Determination 2024/031

**Regarding the compliance of building work with Building
Code clause E1.3.1 Surface water**

57 Pomona Road, Ruby Bay

Figure 2: As-built plan (not to scale).

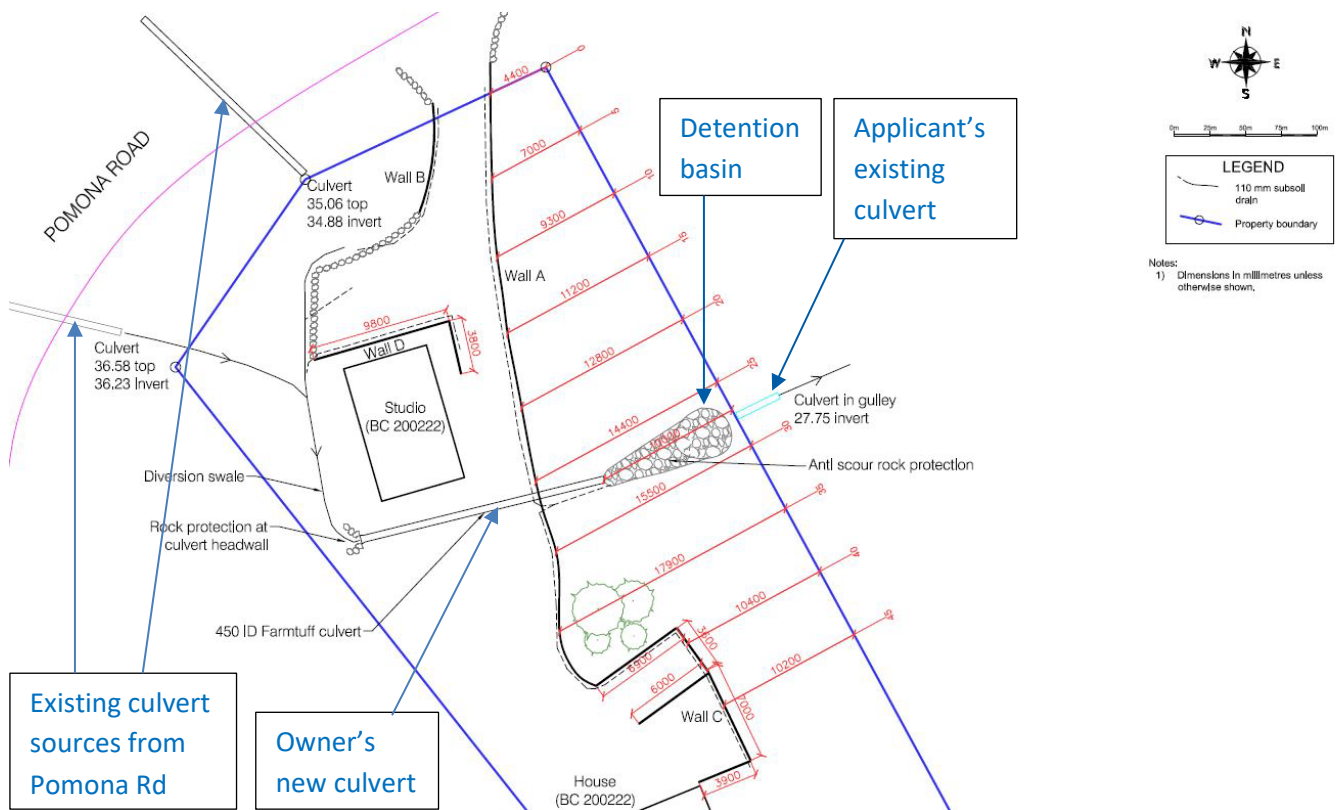
- 2.5. In terms of the pre-existing drainage arrangements, storm water was (and continues to be) collected via overland flow from Pomona and Korepo roads above and from two existing culvert sources.⁵ This water discharged onto 57 Pomona Road which, prior to the building work commencing, was undeveloped and covered with grass and scattered trees. The outflow was (and continues to be) via a culvert which runs beneath the applicant's driveway and into the applicant's property (see Figure 2).

driveway via a 450mm⁶ diameter pipe. Outflow is then dispensed eastward via a rock-lined waterway/swale into a detention basin (see Figures 2 and 3).

Figure 3: Photograph of as-built drainage arrangements (taken 13 July 2021).

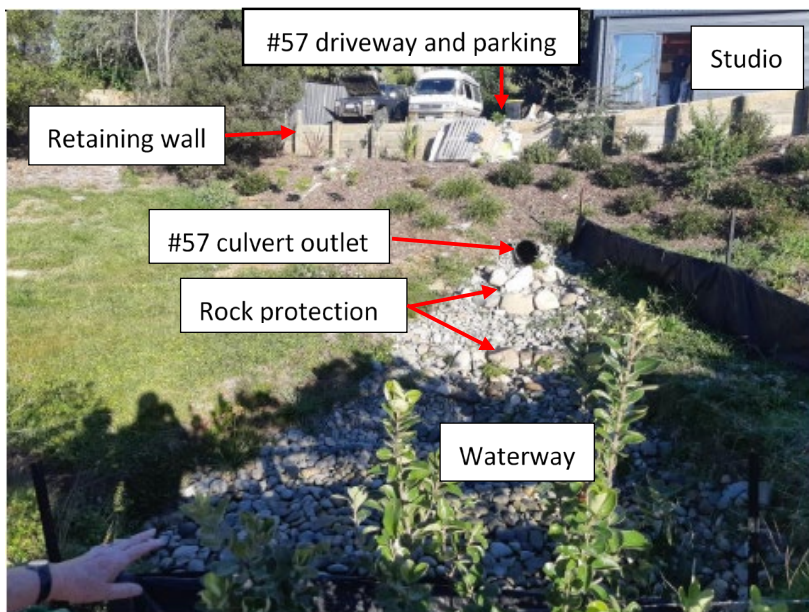
2.6.3. The detention basin is close to the boundary with 53 Pomona Road. The detention basin measures 3m by 3m, is 500mm deep in the centre and is lined with river stone rocks (see Figures 3 and 4).

- 5.3 The experts assessed the 450mm culvert beneath the owner’s new driveway, noting it has been installed in the correct position as per the consent. Although there is no practical secondary flow-path other than over the driveway, substantial ponding upslope would be required before water would overspill the driveway, and it is understood that this has not occurred. The wall and fill are designed to accommodate temporary ponding without significant damage.
- 5.4 Rock protection has been placed at the inlet of the culvert and there are no signs of erosion. Appropriately sized anti-scour rock protection has also been placed below the outlet (see Figure 3).

Figure 7: Rock protection at downstream rise of detention basin (taken 13 July 2021).

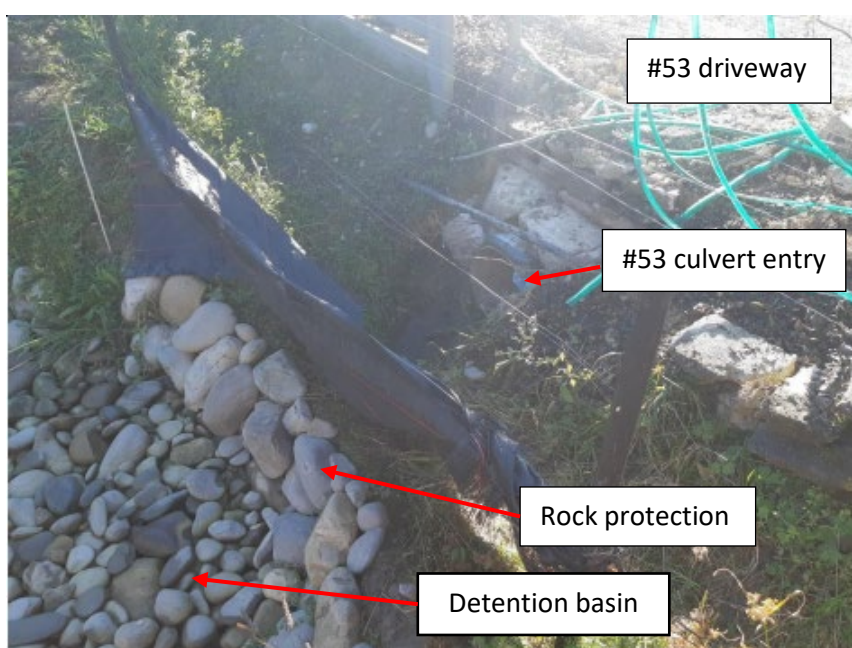
- 5.7 The detention basin's function is "energy dissipation by abrupt rise". Medium sized rock protection has been placed against the downstream rise of the basin (see Figure 7). The report notes that this is compliant with E1; however, the size and placement of the rock will need to be monitored as small rocks may become displaced over time by the force of the water.
- 5.8 Evidence of minor scour to the applicant's culvert entry was noted, which is likely a result of an inadequate headwall arrangement providing a transition of flow into the culvert.

- 6.22. I note the comments made by the engineer and expert that the rock protection should be regularly maintained to ensure the rocks continue to provide protection to dissipate the flow of water. I consider the work to check and replace any rocks is normal maintenance expected in accordance with Clause B2 Durability.
